**Letter of Explanation  
for  
Variance Request**

**Subject property:** 2008 Fraley Lane  
Pasadena, MD 21122

PERMIT - B02428933

NUMBER: 2024-0170-V

**LOCATION DRAWING OF:**  
**#2008 FRALEY LANE**  
**LOT 4-R**  
 3rd ASSESSMENT DISTRICT  
**BAYSIDE THIRTY**  
 PLAT BOOK 160, PLAT 42  
 ANNE ARUNDEL COUNTY, MARYLAND  
 SCALE: 1"=150' DATE: 1-24-17  
 DRAWN BY: AP FILE #: 170353-607

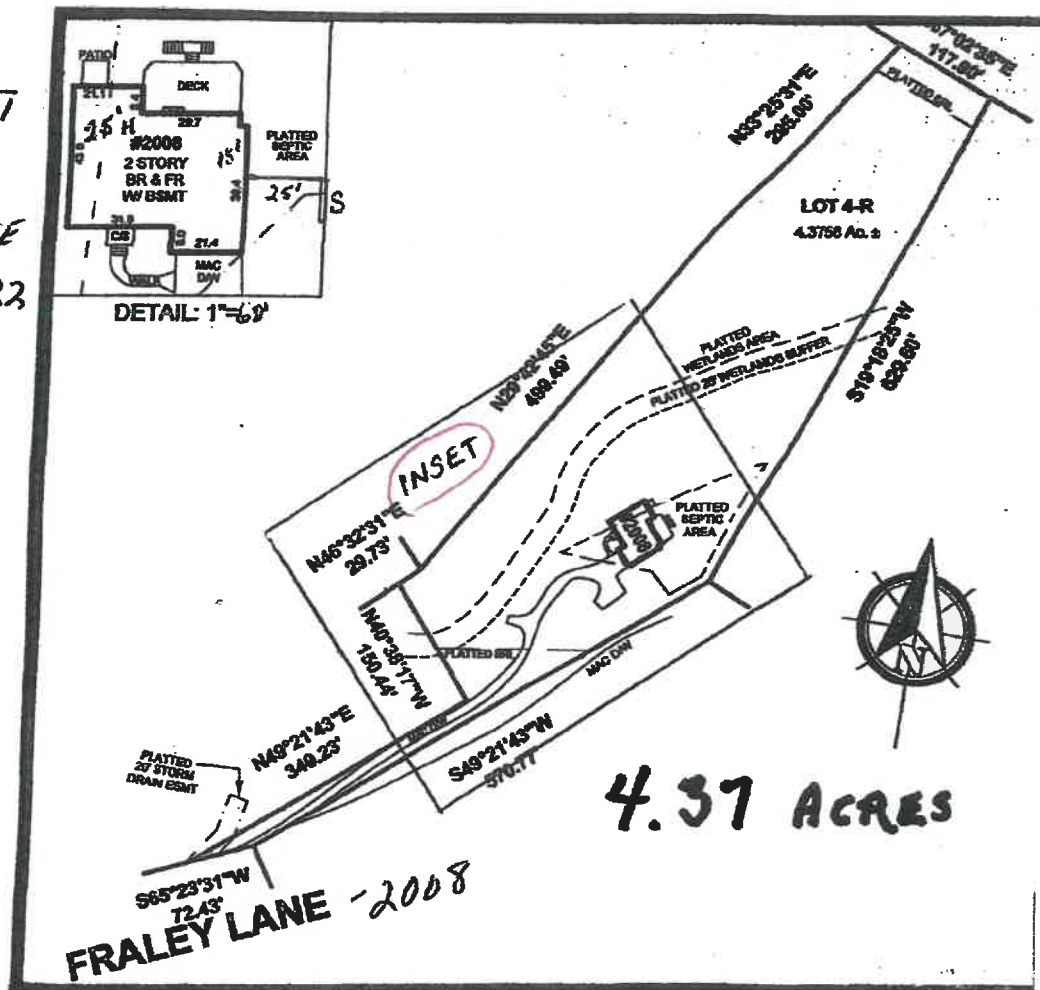
In accordance with Article 18-2-204(b), an accessory structure may not be located in the front yard of a non-waterfront lot. Revise the site plan to meet this requirement. If this is not possible, a variance to the setback requirements is required. Contact the Office of Planning and Zoning at (410) 222-7437 for additional information concerning the variance process or use the link here: <https://www.aacounty.org/planning-and-zoning/support>
